ZONING DIVISION
LEE COUNTY
PLANNED DEVELOPMENT SUFFICIENCY REVIEW
TRANSMITTAL SHEET

PROJECT NAME: BERMUDA LAKES RV RESORT RVPD

CASE #: DCI2014-00010

Re: The 07/14/14 Lee County Bermuda Lakes RVPD Sufficiency Response

MASTER CONCEPT PLAN THE BERMUDA LAKES RV RESORT PLANNED DEVELOPMENT LEE COUNTY, FLORIDA							
DATE	PROJECT	DRAWING	DESIGN	DRAWN	CHECKED	SCALE	SHEET
5/12/2014	2062NT	MCP		EMH		1"=100'	1

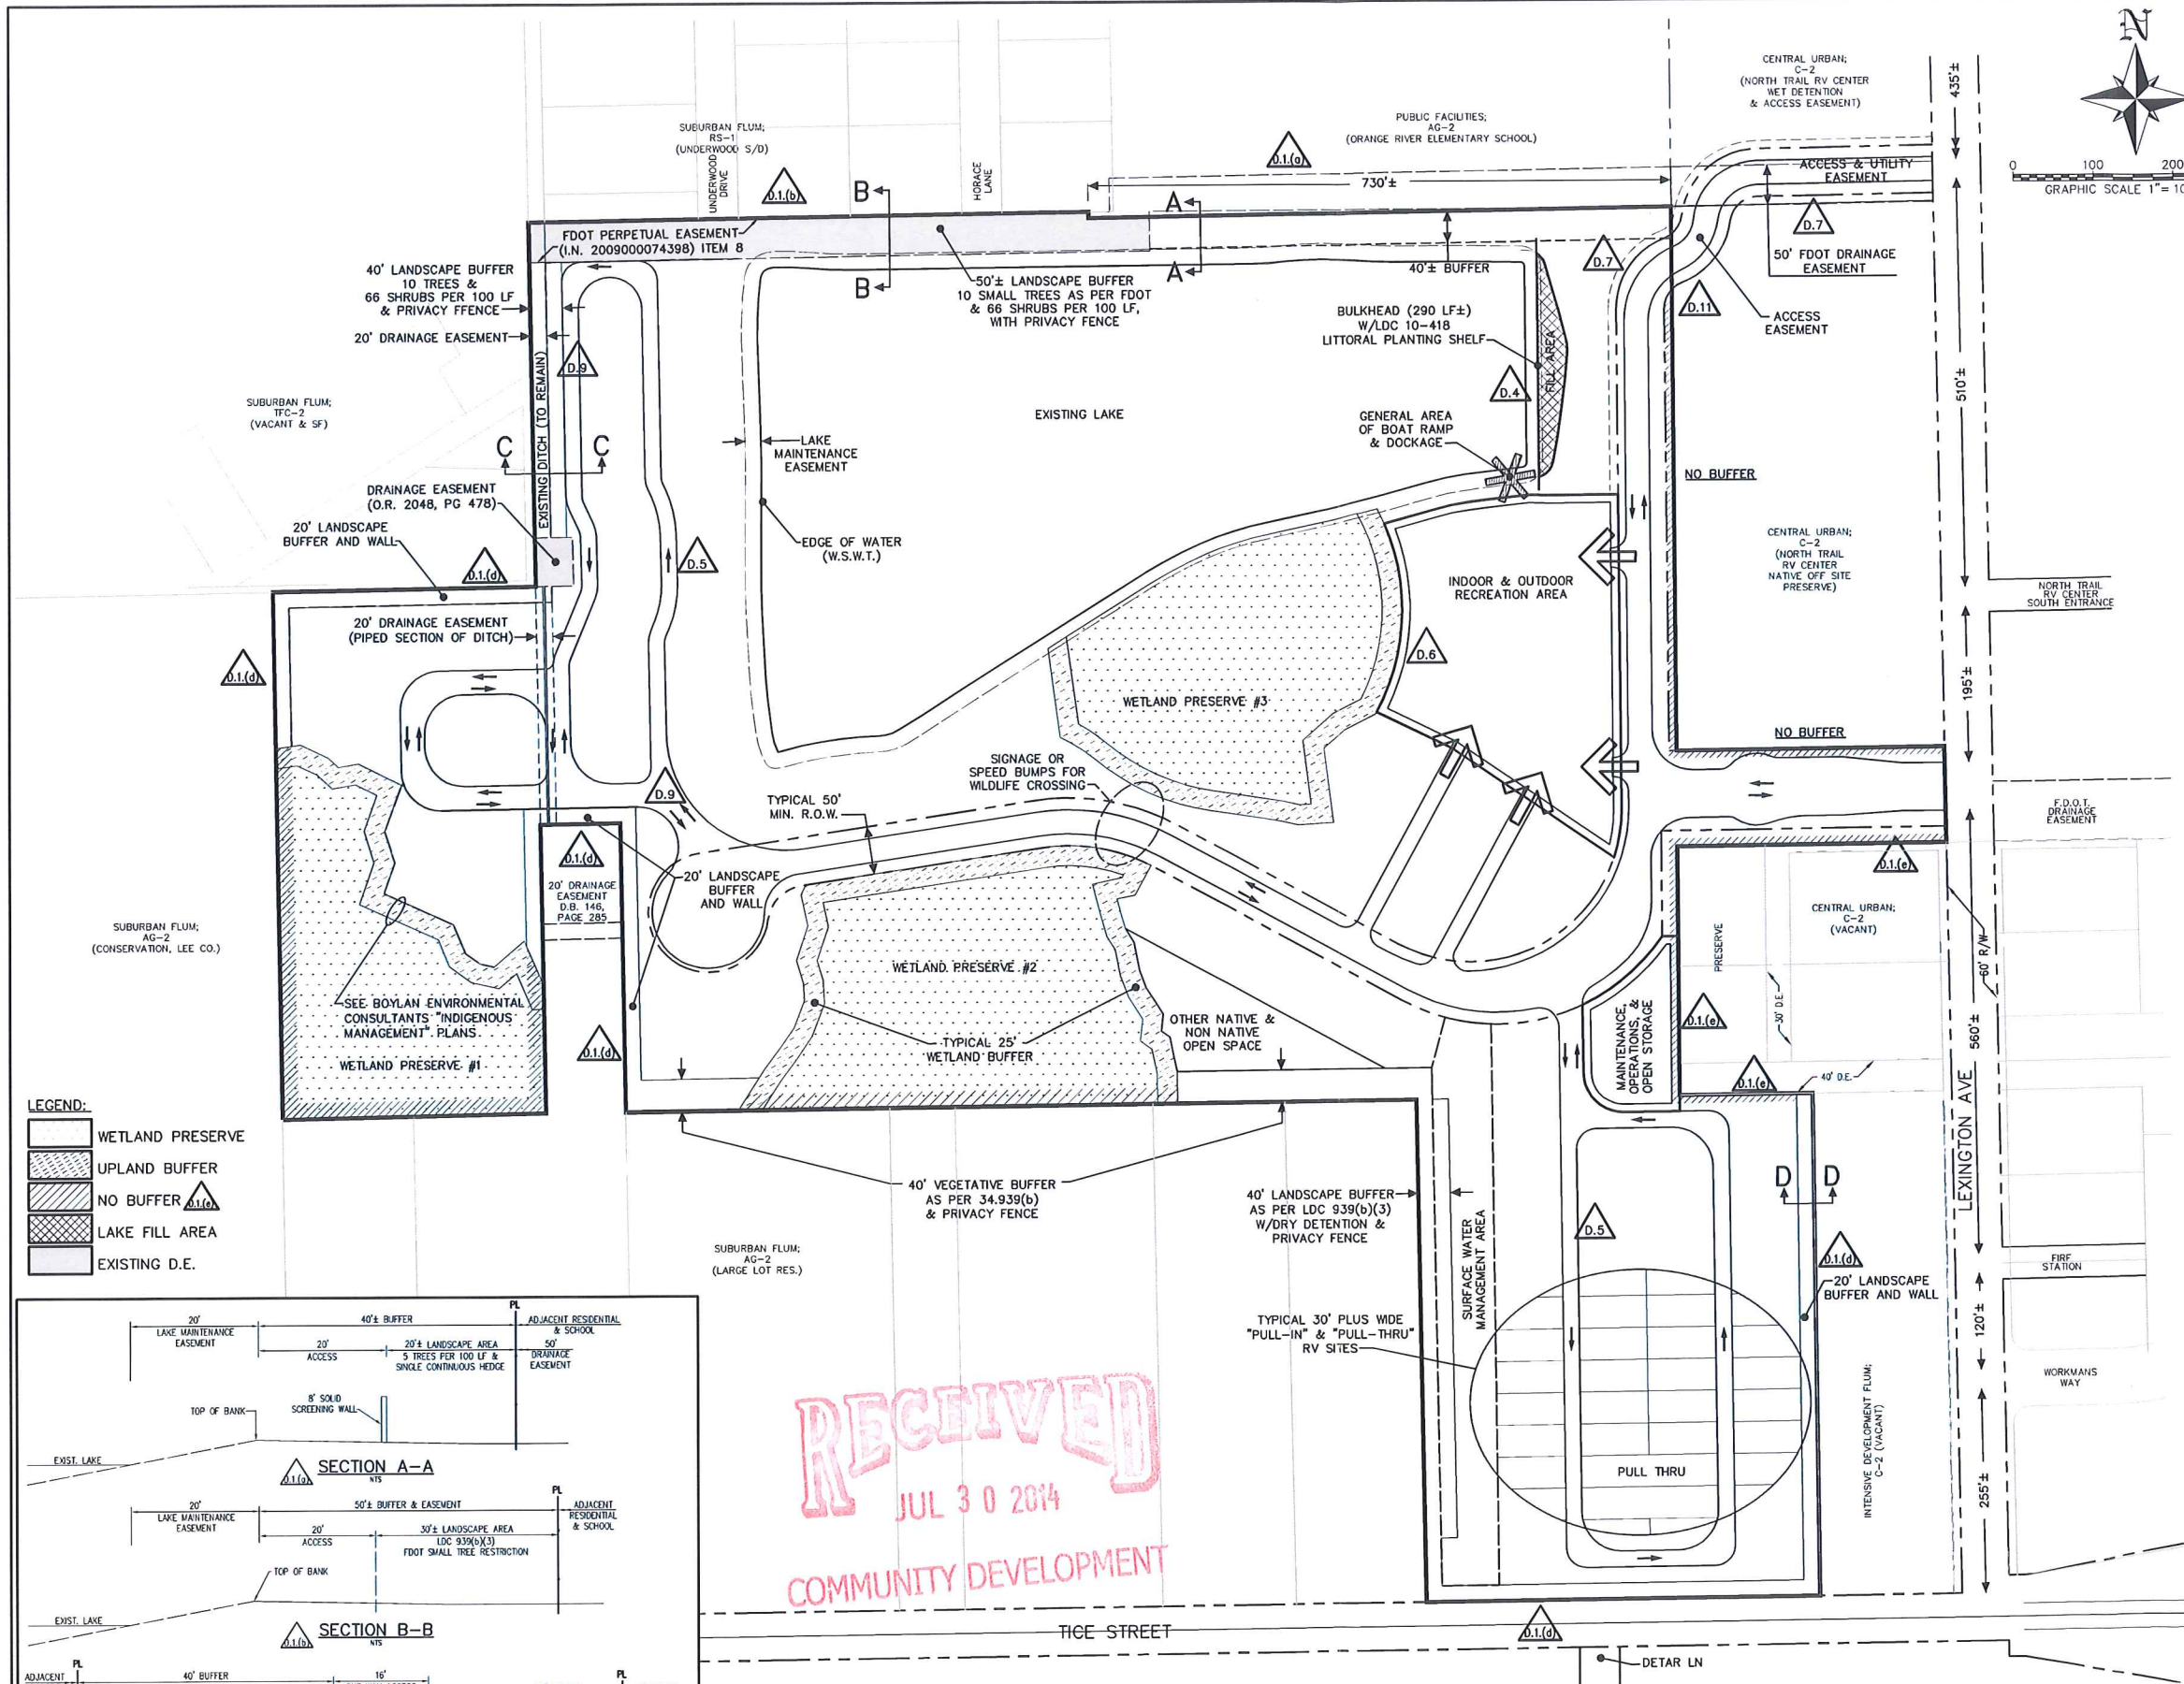
- 12a **Easements** - The revised MCP incorporates and identifies the two public easements by their Instrument Numbers. A new easement will be granted through the commonly owned adjoining C-2 property (see Exit 21 LLC Sunbiz Doc. #L1200002270). The easement will maintain FDOT access rights.

- 12j **Easement Use and Encroachment** - The MCP has been revised to label the subject C-2 property as Preserve as per DO 89-07-019-00D and Plat Bk 63 Pg 98.

The MCP's western RV loop access way design has been modified in a manner that avoids the west boundary drainage discharge easement (Section C:C). Hence written documentation pertaining to use and encroachment will not be needed. The response to providing written documentation pertaining to use and encroachment into the FDOT Access Easement located along the northwest lake segment is as follows. Please see the attachment to this correspondence, FDOT Perpetual Easement Instrument # 2009000074398, dated 03/23/09 (see MCP's Section B:B). The subject 50-ft. wide Perpetual Easement granted to FDOT for storm water management construction and maintenance access is non-exclusive. It specifically permits the property owner to use the easement for a road, driveway, parking, landscaping, utilities, signs, dry detention and density calculations for future property development. The easement stipulates that the owner may not construct improvements on the parcel that will interfere with FDOT easement use. The Perpetual Easement specifically identifies large trees, ponds, buildings and signs as being prohibited within the easement. The Applicant has modified the Deviation 1(b) request to be consistent with the identified large tree prohibition. Please refer to the revised Exhibit 19 Deviation Schedule.

- 12K **Excavations** - The MCP and Exhibit 19 have been revised to eliminate Deviation Three Littoral Shelf Plantings LDC 10-418(2)(a, b, c, d). A deviation to LDC 10-418(a) Shoreline Configuration, Deviation 4, is being requested for the 290-ft. +/- eastern lake edge. Littoral shelf plantings will be required though not within a sinuous shoreline configuration. The Applicant is proposing a linear bulk head for the subject east lake area.

- 13 **Uses** - The MCP has been revised to identify Boat Ramp and Dockage.
- 14 **Deviation 1 Buffers** - Please refer to the revised MCP and Ex.19 Deviation Schedule. Buffer deviations are sub-categorized into four distinct requests. For common ownership documentation please download **Exit 21 LLC** Sunbiz Doc. #L1200002270, Alan Erp, Manager.

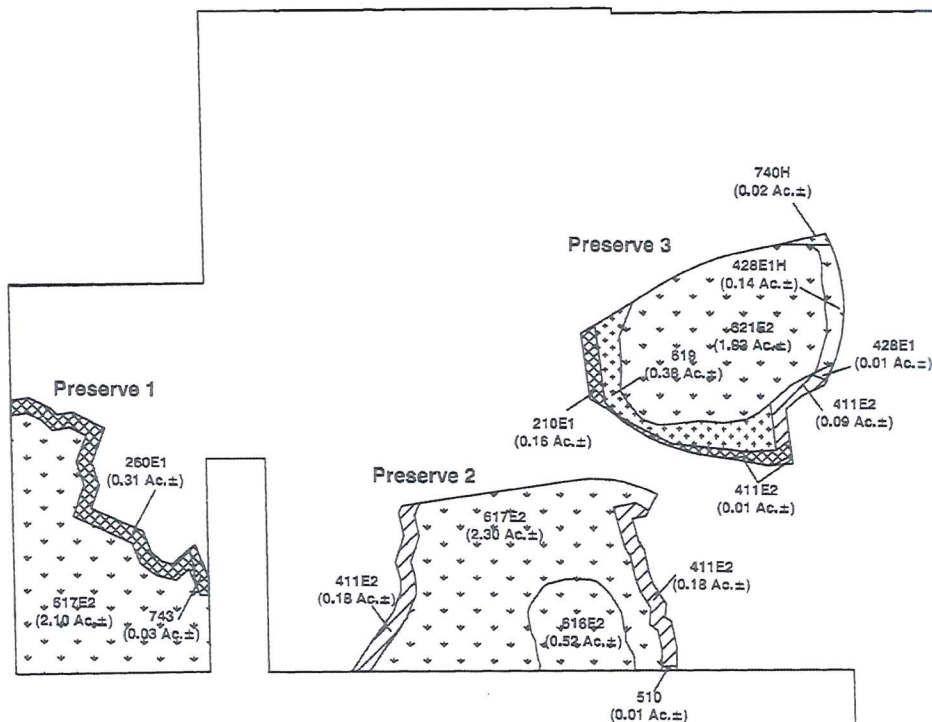
- 12h **Open Space Design Plan** - Please refer to the revised Boylan Environmental Consultants revised Indigenous Preserve Map and Indigenous Vegetation Credit Table. The Applicant has revised the native vegetation calculations by removing non-native wetland buffer areas from the calculations. The project requires 7.31-acres of native open space; the project is providing 7.46-acres of native open space. Finally, please see the submitted Indigenous Management Plan, FLUCCS Map and MCP in regard to buffers surrounding the wetland conservation areas. The non-native FLUCCS 260E1 around Preserve 1, the non-native FLUCCS 510 around Preserve 2 and the non-native 210E1 and 740H around Preserve 3 are excluded from the project's Native Open Space calculations.
